## PHEASANT BRANCH GREENWAY ENHANCEMENT

CITY PROJECT NO. 14370

ADDENDUM #2  
REVISED THE FOLLOWING:  
SHEETS D1-D3  
SHEETS EC1-EC4  
SHEETS G13, G15, G112  
SHEETS P1-P19, P21, P24-27  
SHEETS U1-U18, U22  
SHEETS E1-E6  
SHEET PM1  
SHEETS X32A-X34, X45-X48

STREET PLAN & PROFILE - FOURIER DR.  
 PHEASANT BRANCH GREENWAY ENHANCEMENT

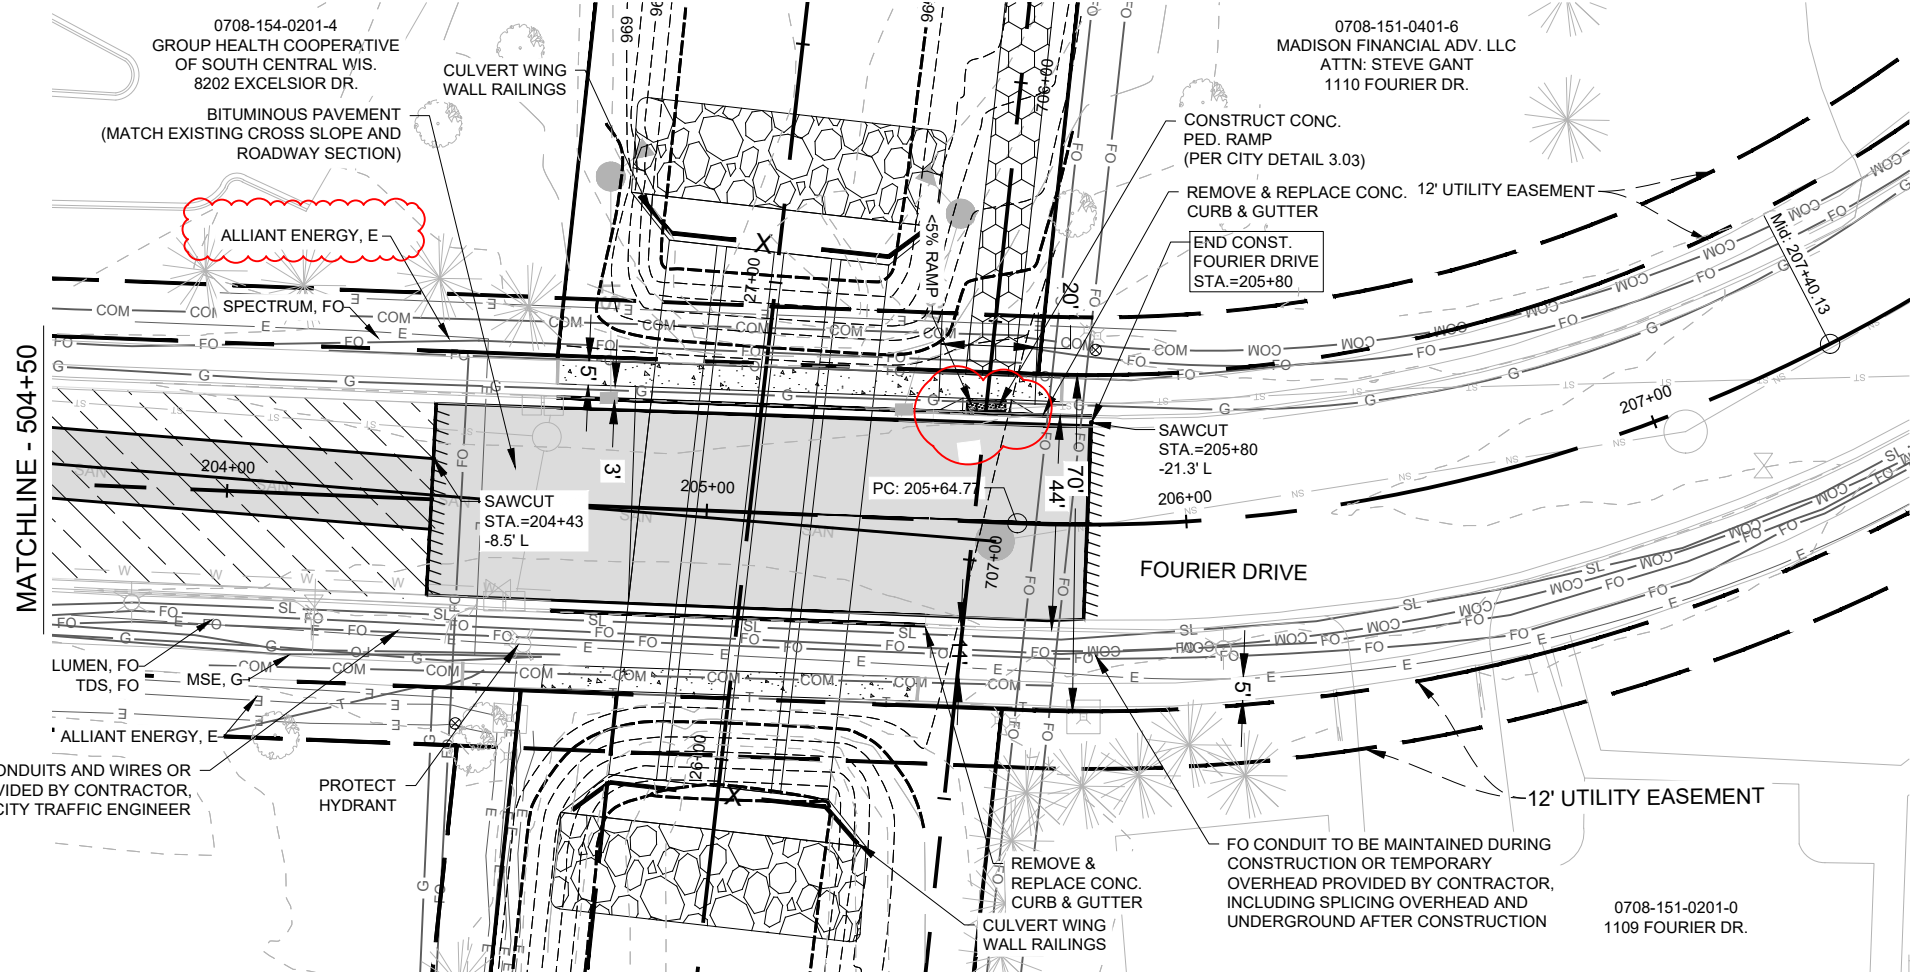
**ADDENDUM NOTE:**  
 -UPDATED LEGEND  
 -ADDED DETECTABLE WARNING  
 -ADDED PRIVATE UTILITY LABELS

14370	MADISON, WI	REVISION	DATE	BY	P6
14370	MADISON, WI	Designed By: JFC	Date: 11/06/2024 4:00 PM	Scale: AS SHOWN	P6
<b>STREET PLAN &amp; PROFILE - BLACKHAWK</b>					
<b>PHEASANT BRANCH GREENWAY ENHANCEMENT</b>					
CONTRACT NO: 9517					
14370					
P6

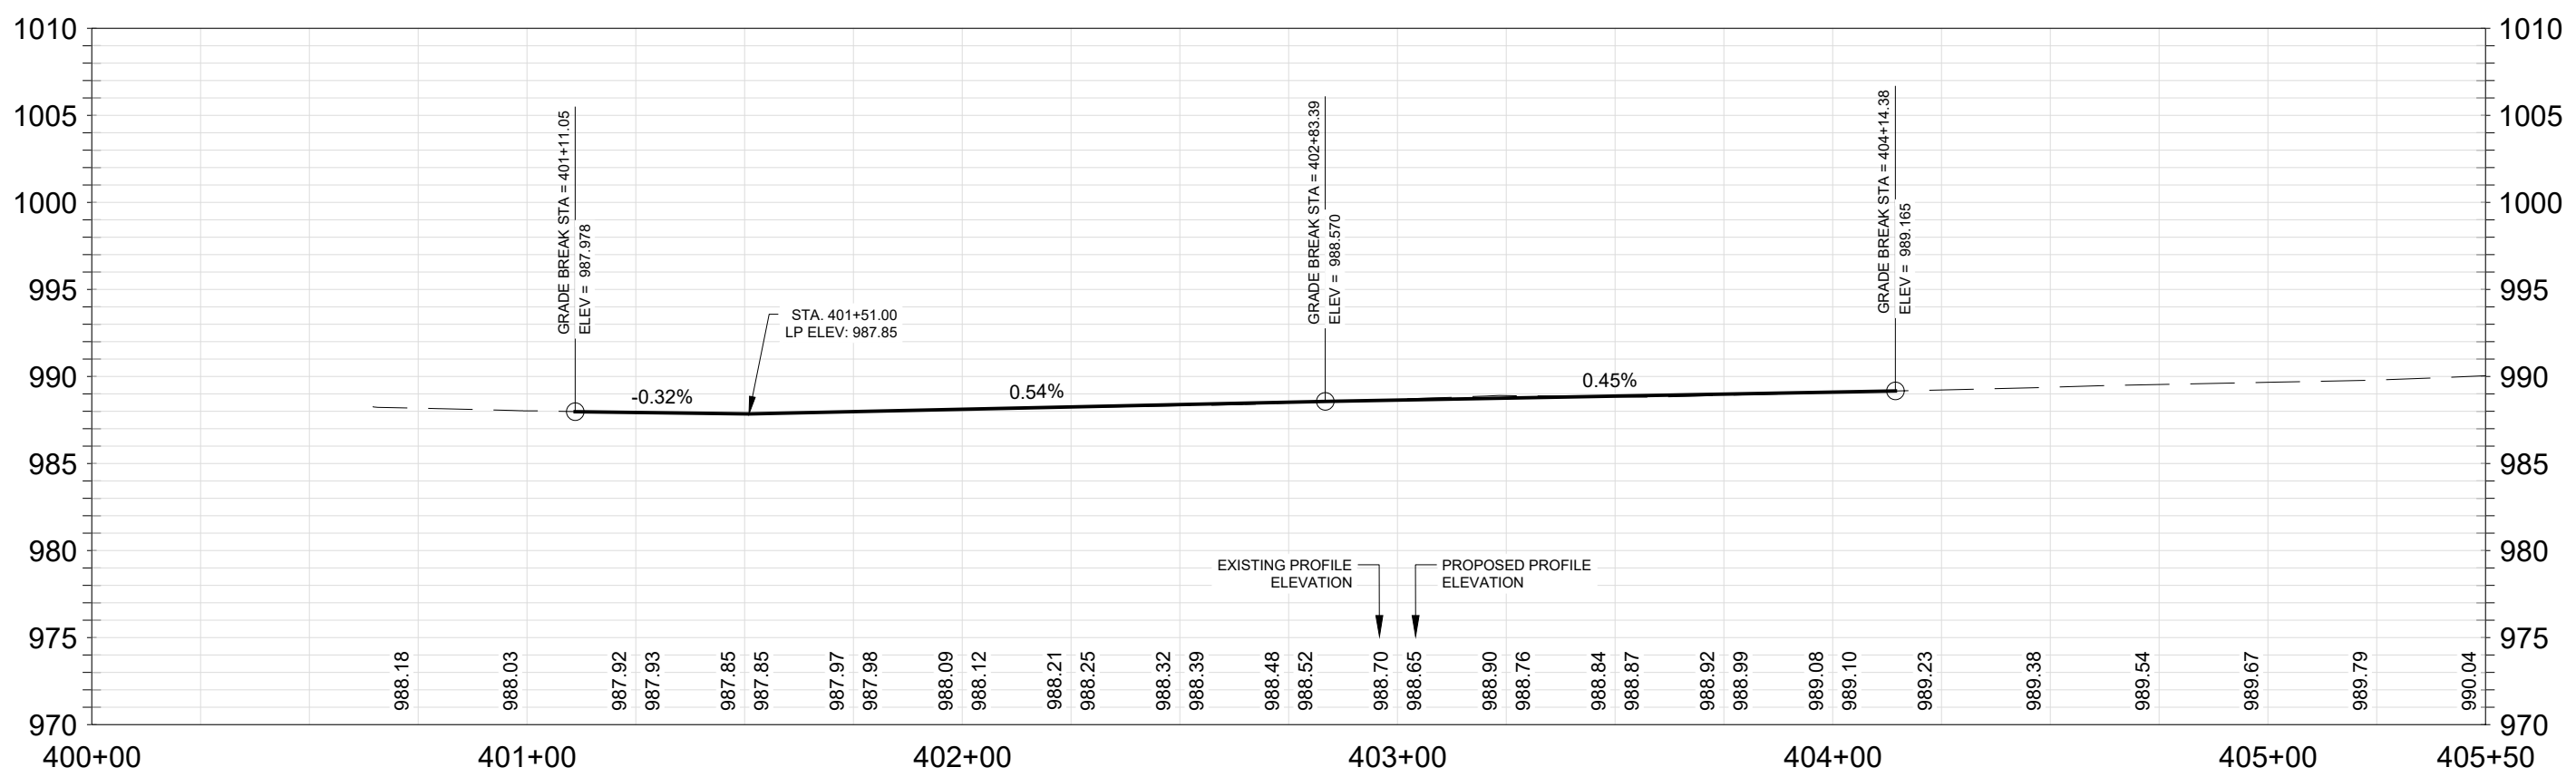
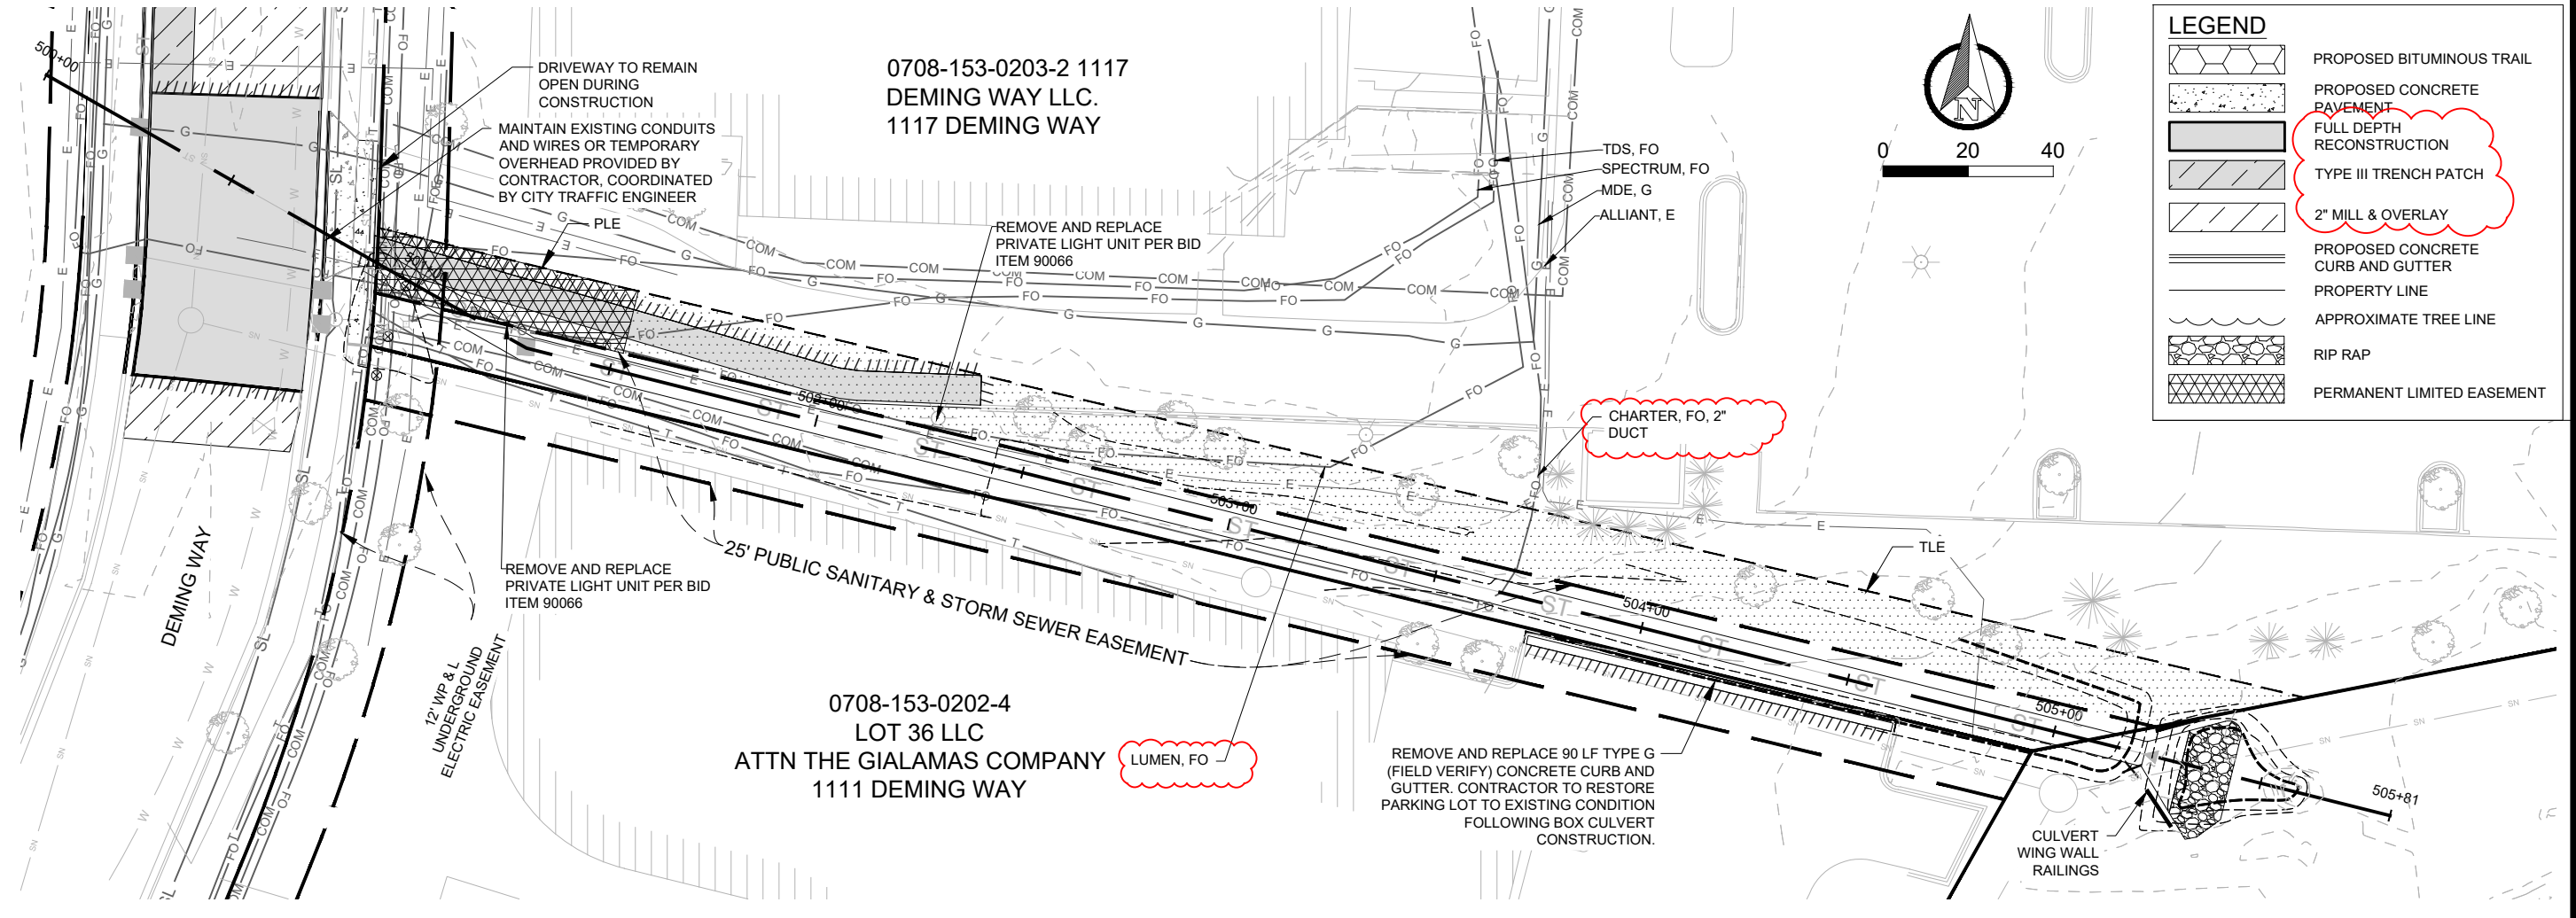
**ADDENDUM NOTE:**  
 -UPDATED LEGEND  
 -ADDED DETECTABLE WARNINGS  
 -UPDATED NOTES

14370  
P8

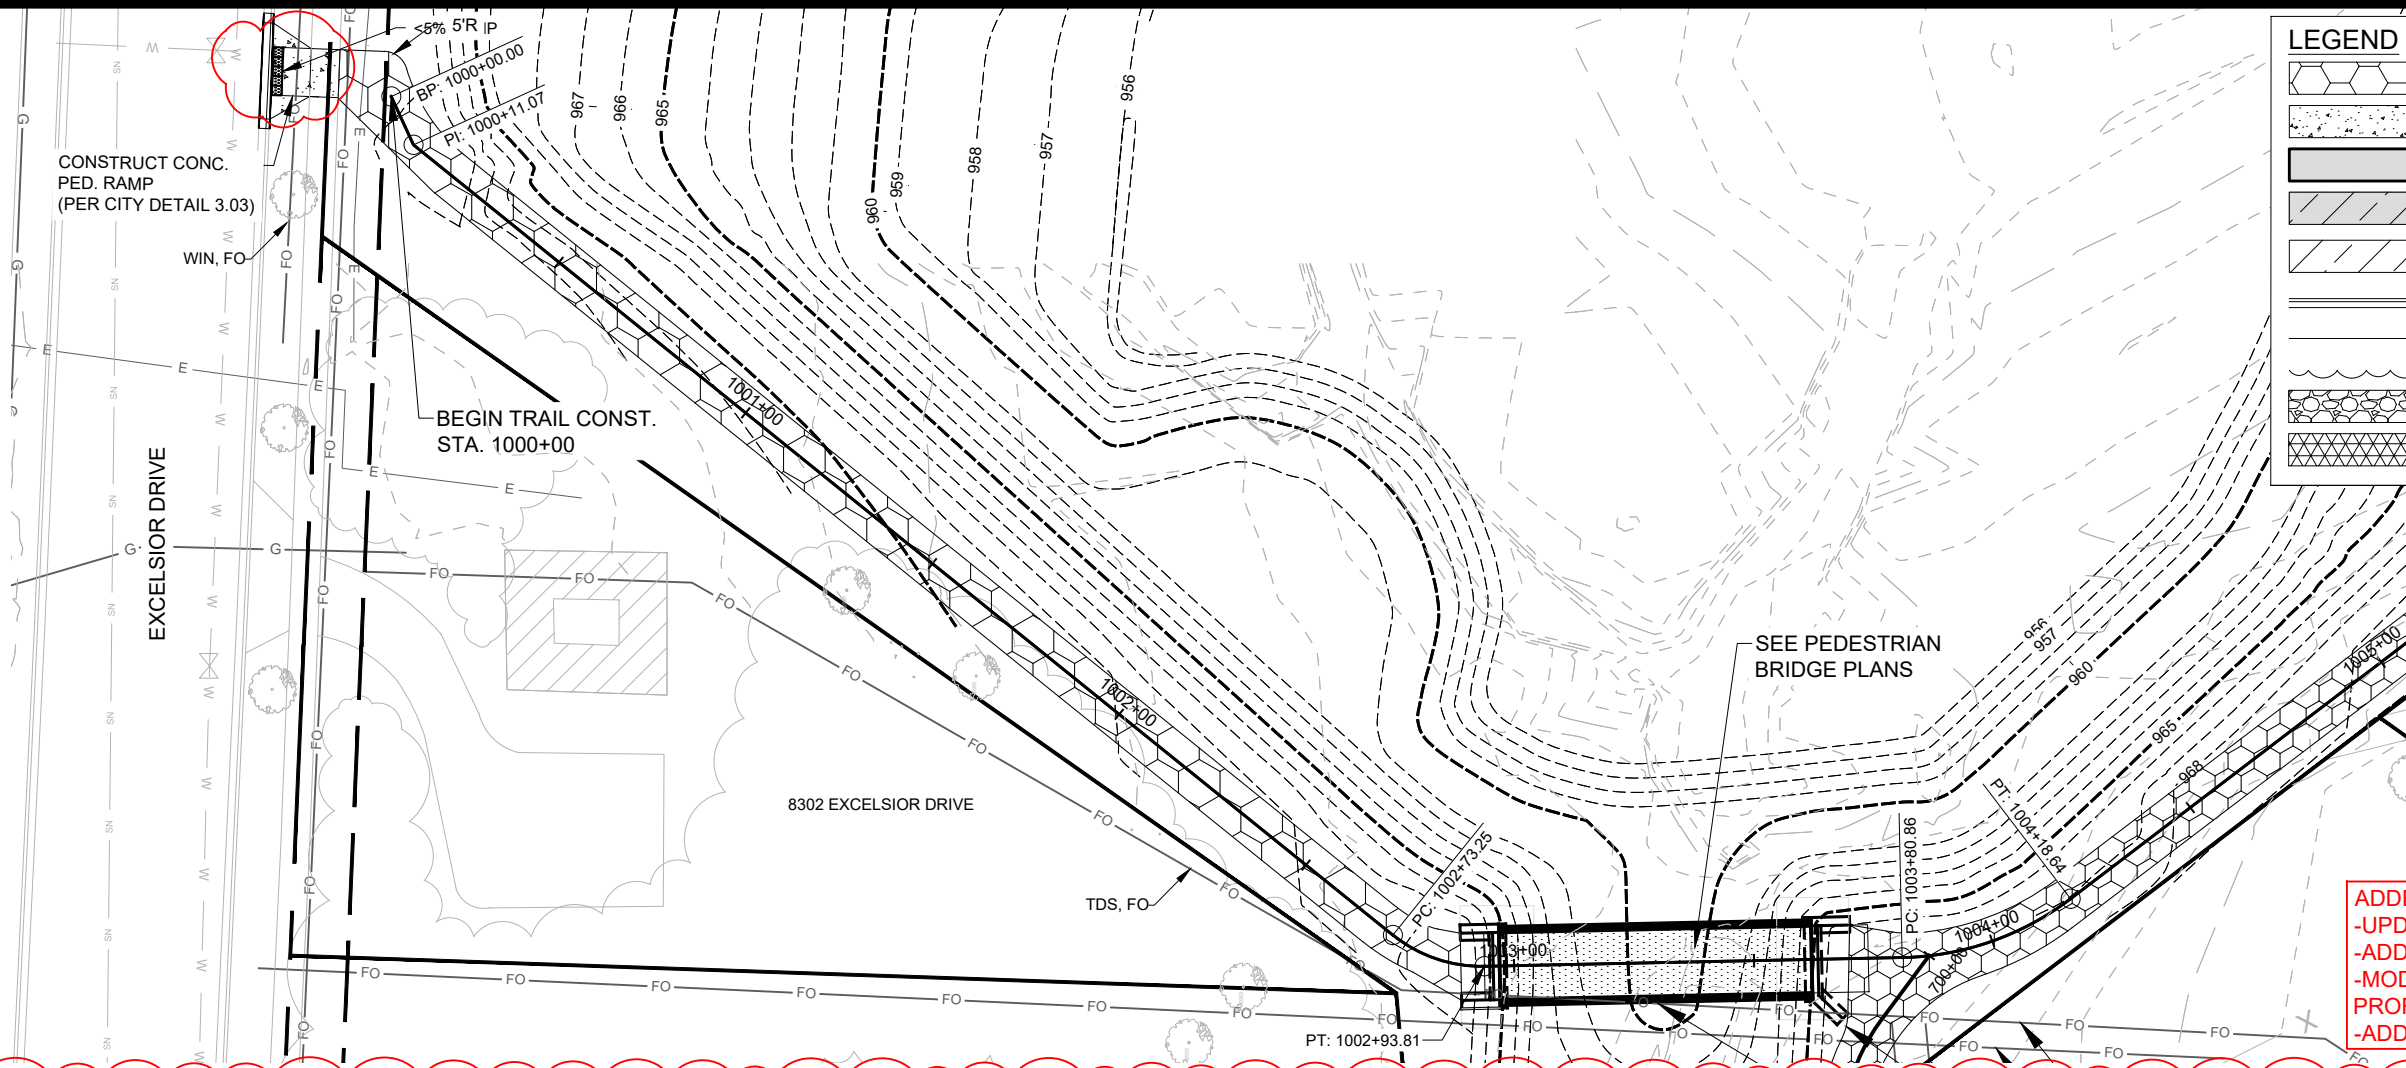
**ADDENDUM NOTE:**  
-UPDATED LEGEND  
-UPDATED ACCESS ROAD NOTE
